February 4, 2004 BZA

REQUEST ANALYSIS  
AND  
RECOMMENDATION

04AN0192

**REQUEST:** A twenty-three (23) parking space Variance to the 160 parking space requirement in a light industrial (I-1) District.

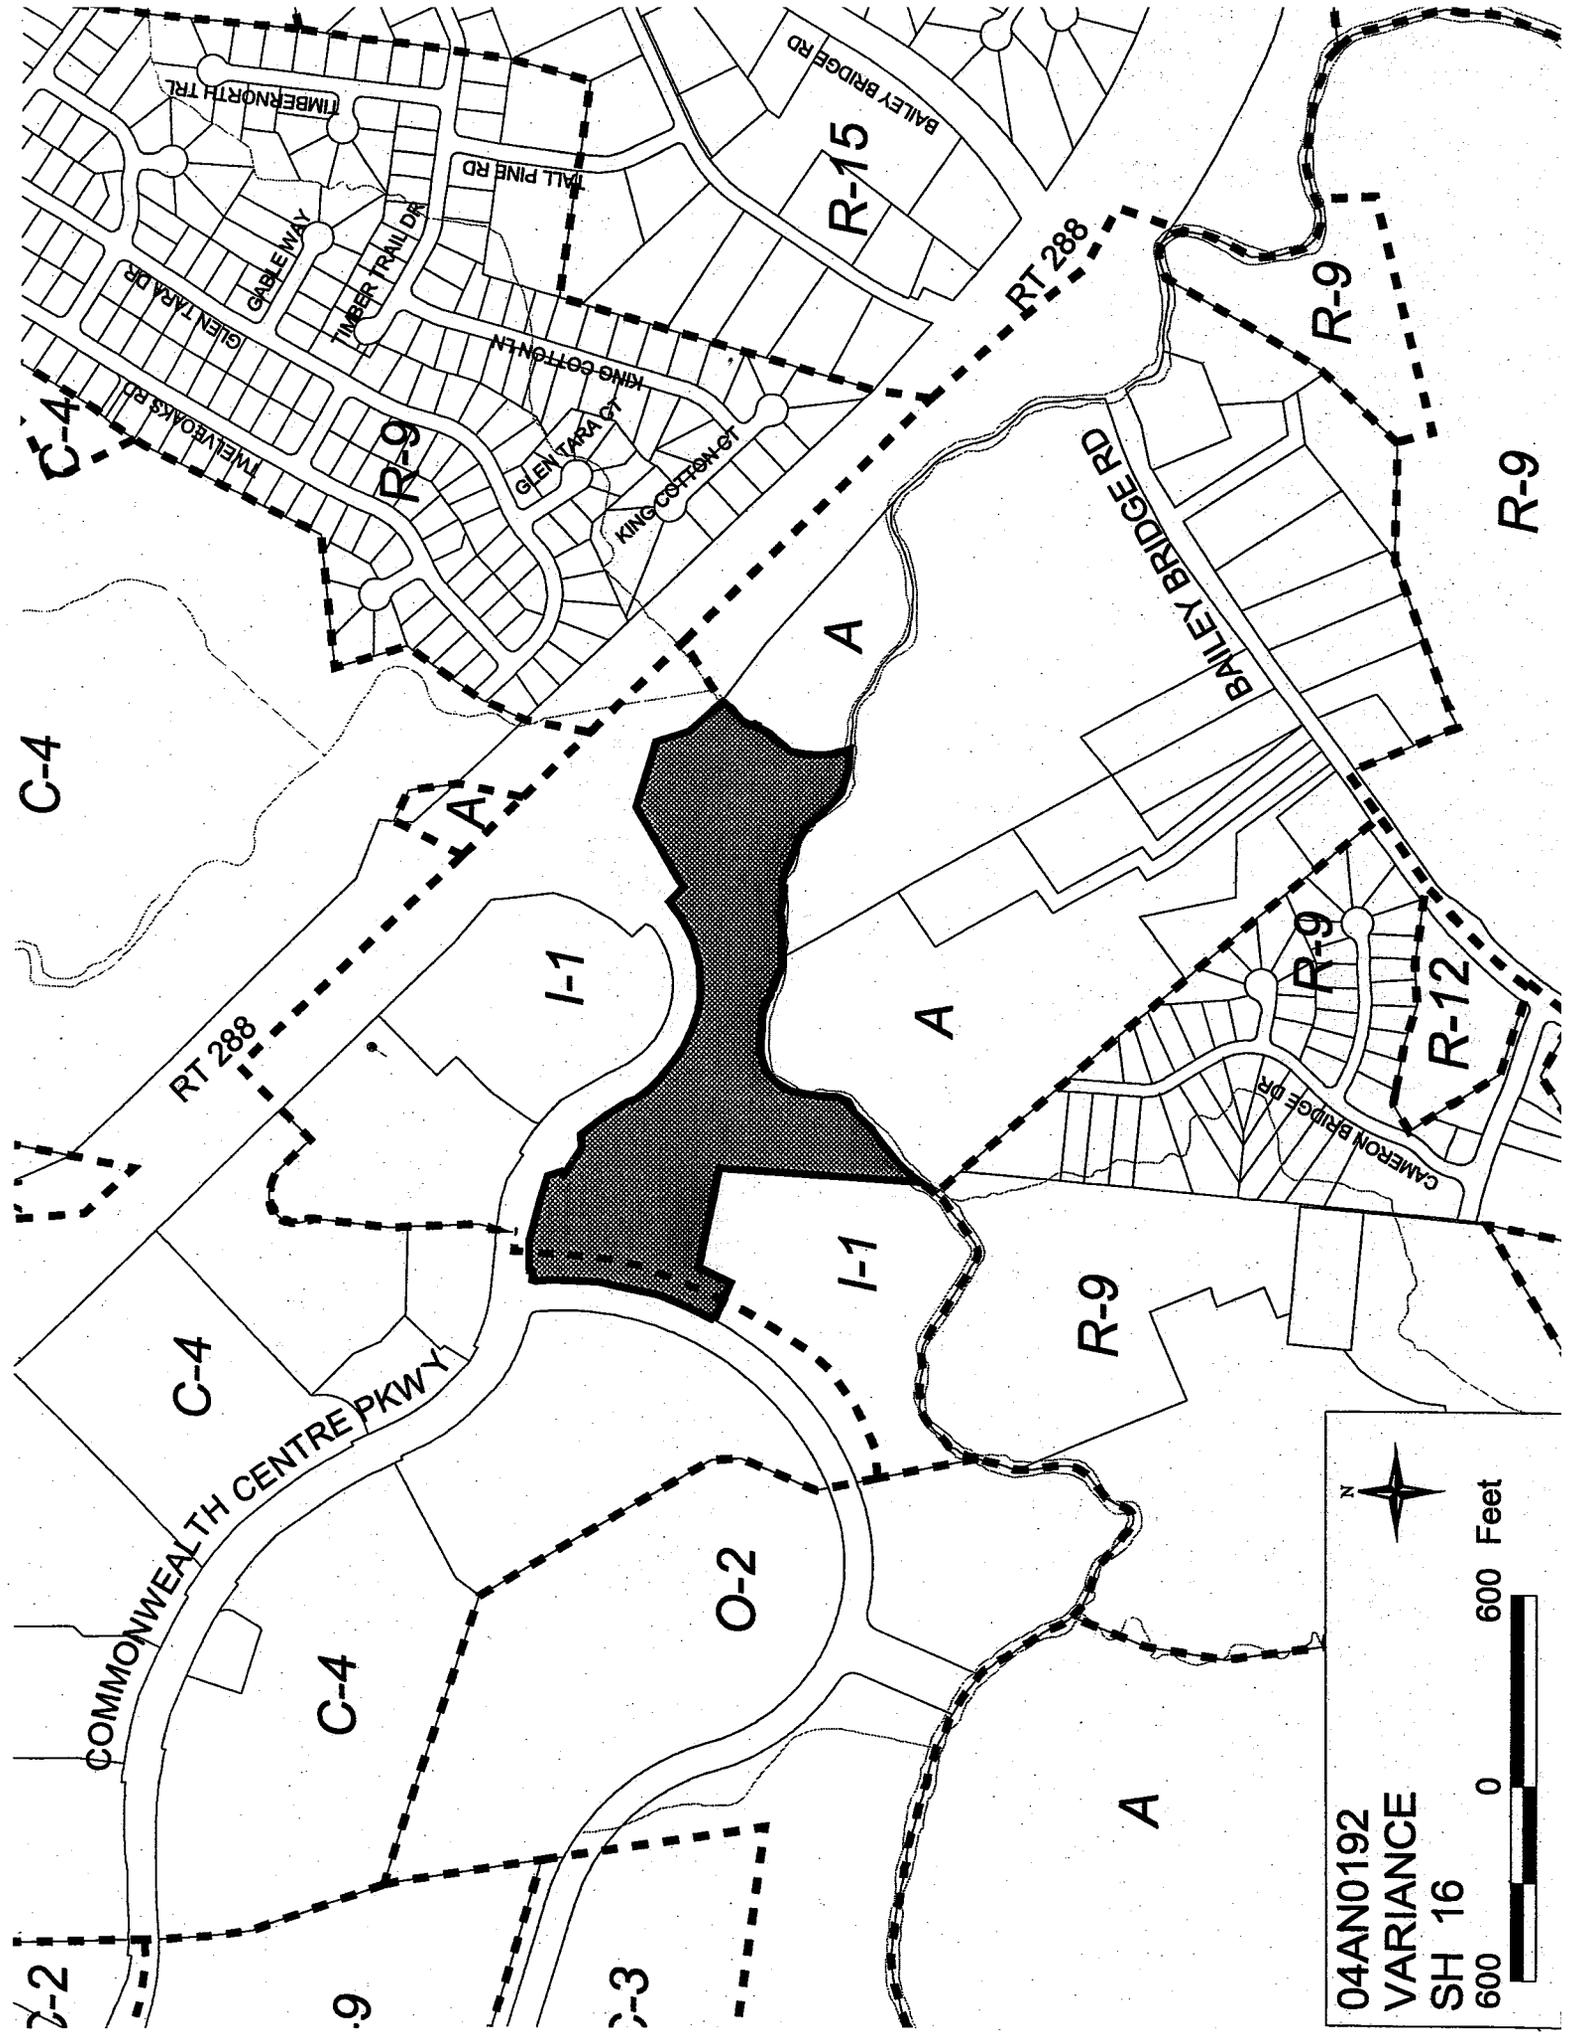
Staff has reviewed the attached site plan and application. Staff notes the graphics reflect 161 parking spaces. The applicant has indicated they plan on leveling and seeding but not paving, twenty-four (24) parking spaces of the parking lot.

Staff believes that an alternative exists to this request which does not violate parking space requirements. The applicant's site plan reflects the required parking space. If the applicant were to pave the twenty-four (24) spaces shown on the site plan it would eliminate the need for this request.
